London Luton Airport Expansion

**8.118 Applicant's Response to Issue Specific Hearing 4
Action 7 - Update on Road Safety Audits**

**London Luton Airport Expansion Development Consent
Order 202x**

Report title:	Stage 1 Road Safety Audit Designer's Response- M1 Junction 10
Date:	November 2023
Document Reference and Revision:	TR020001/APP/8.118
Prepared by:	Neil Scott
On behalf of:	Luton Rising

Figure 3.3: A1081 New Airport Way / B653 Gipsy Lane Link SSD

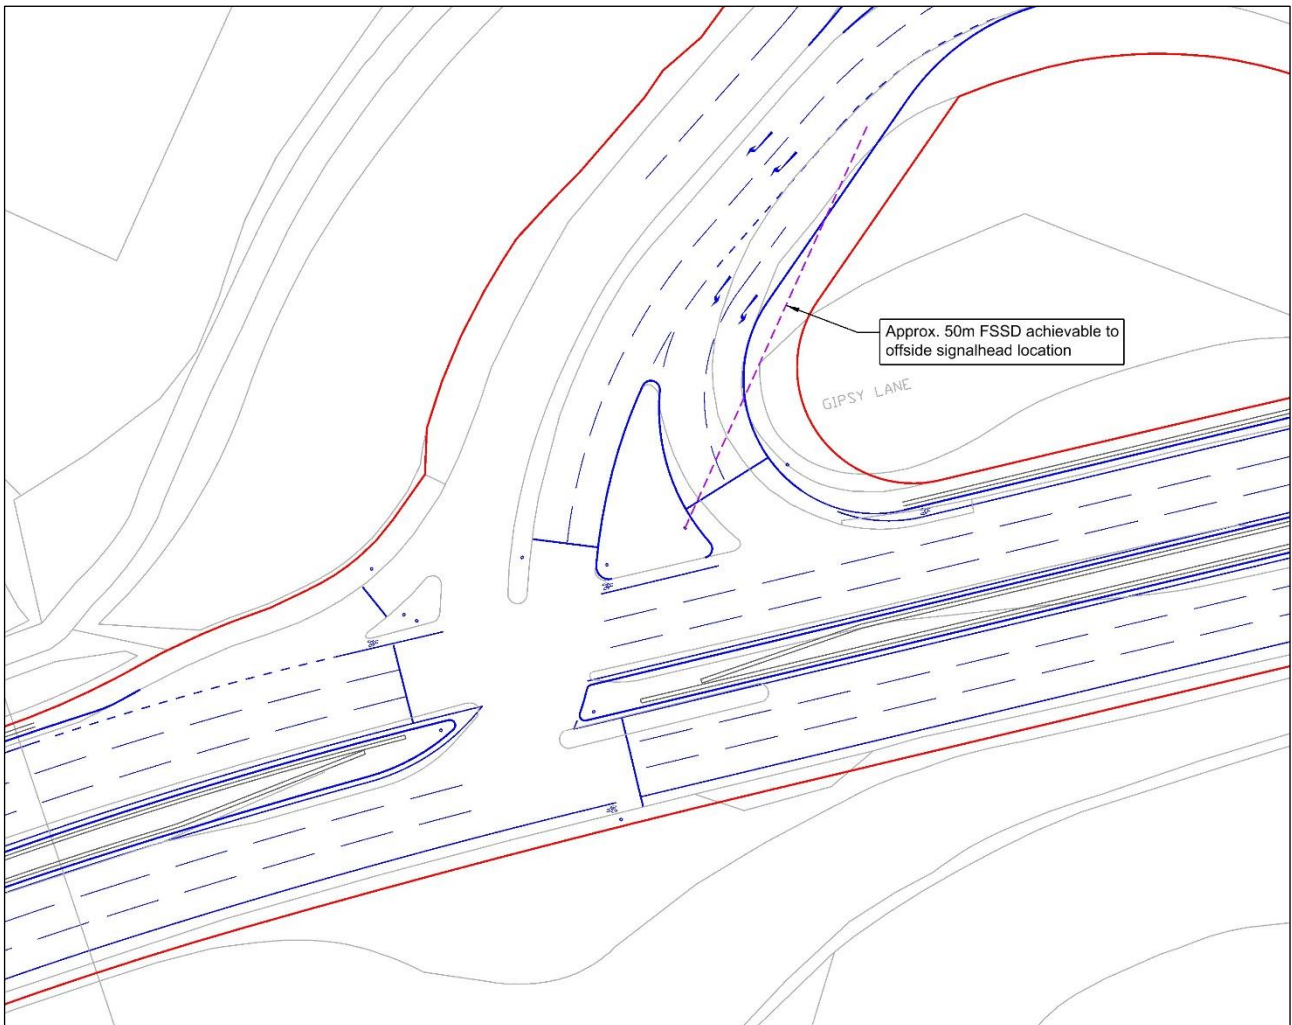
3.3.1 Figure 3.3 above shows the proposed SSD to the offside signalhead. A SSD of at least 50m SSD to a primary signalhead for the left turn is achievable (covering the entirety of the left turn lanes) without removing significant amounts of trees, which is an improvement over the current SSD of approximately 38m.

Figure 3.1: Forward Stopping Sight Distance to Signalhead

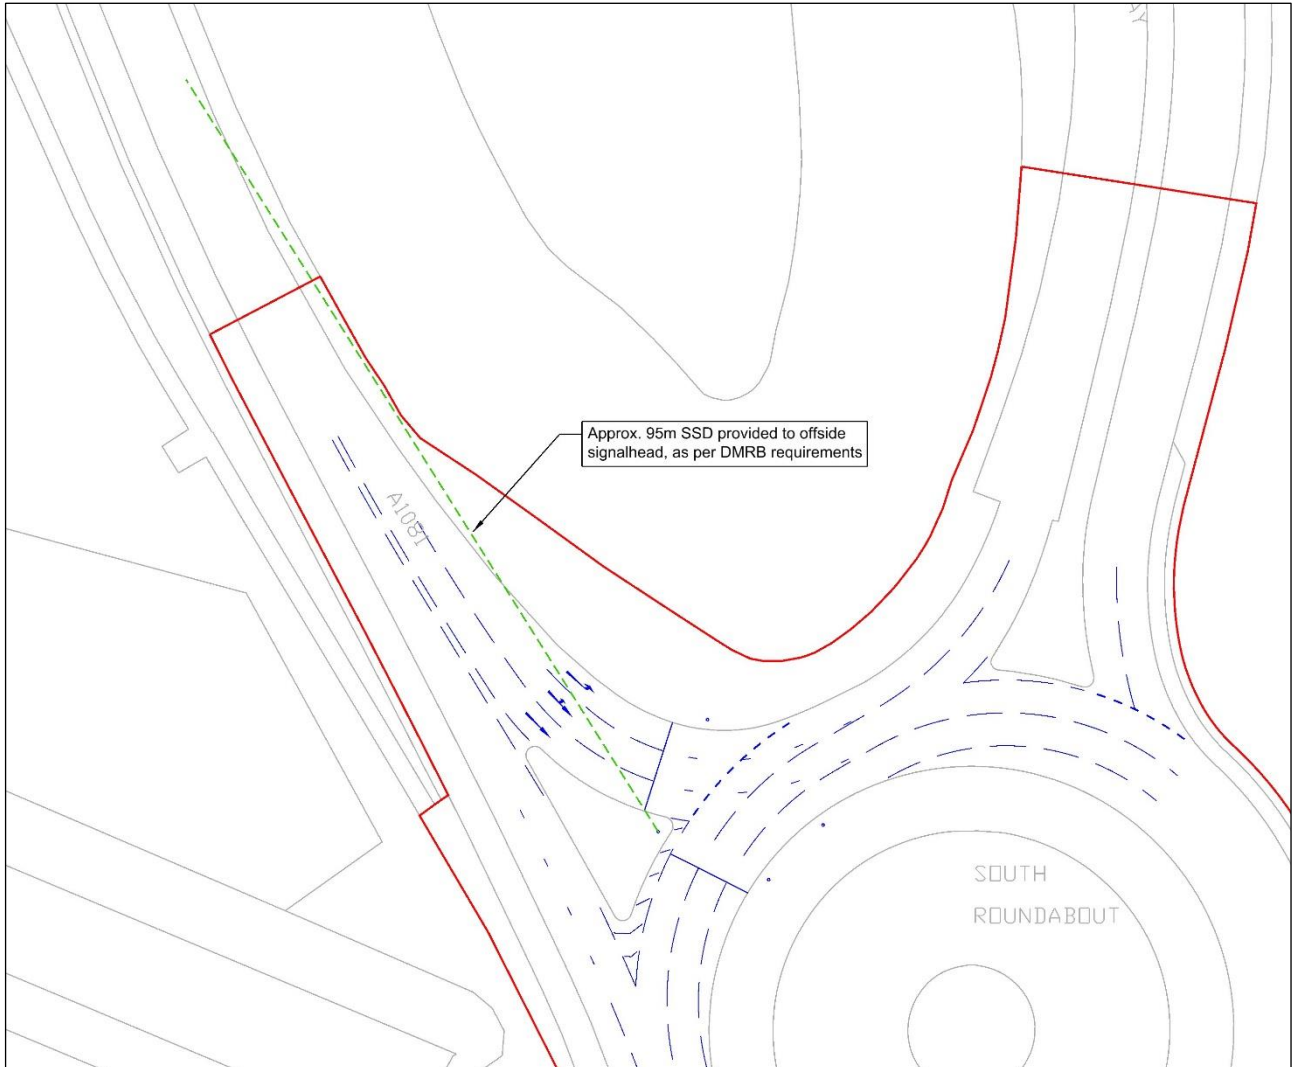
3.2.1 Figure 3.1, above, shows that the Desirable Minimum FSSD to the offside signalhead can be achieved in line with DMRB guidance for a 30mph speed limit (90m). Paragraph 4.7 of CD116 states:
